2013 PROPOSED CHANGES TO THE INTERNATIONAL FIRE CODE

INTERNATIONAL FIRE CODE COMMITTEE

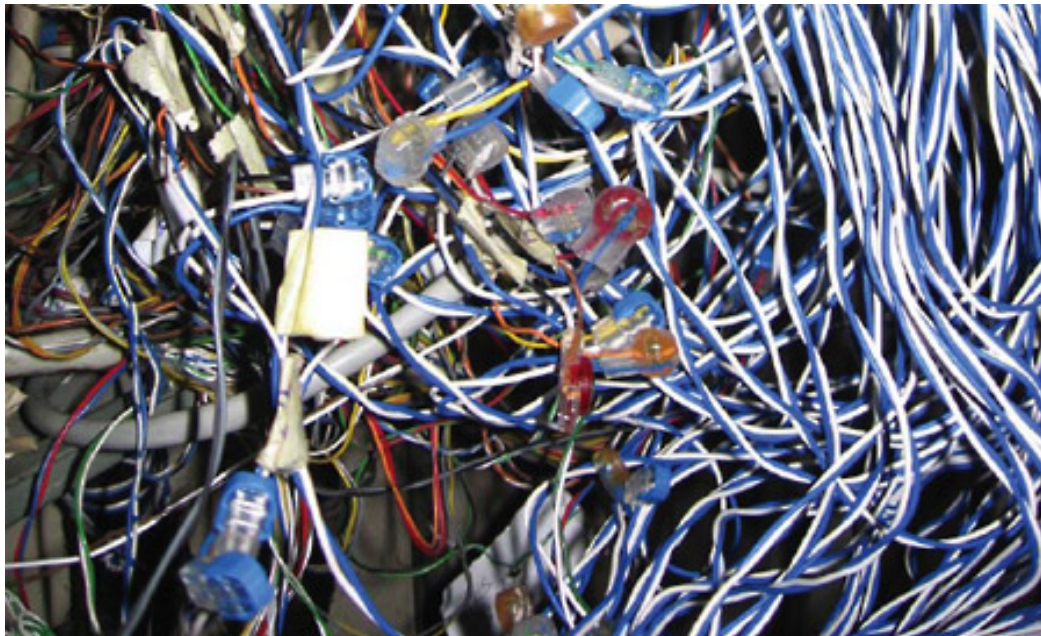
This issue is particularly suitable for Chapter 6 (and section 605) of the IFC since it addresses electrical equipment, wiring and hazards, which are not necessarily electrical hazards but address other safety issues, such as illumination, temporary wiring and unapproved conditions, compliance with all of which is being inspected by the fire code official.

Photographs of typical wiring in plenums, as found by Davidson and DeCrane, follow:
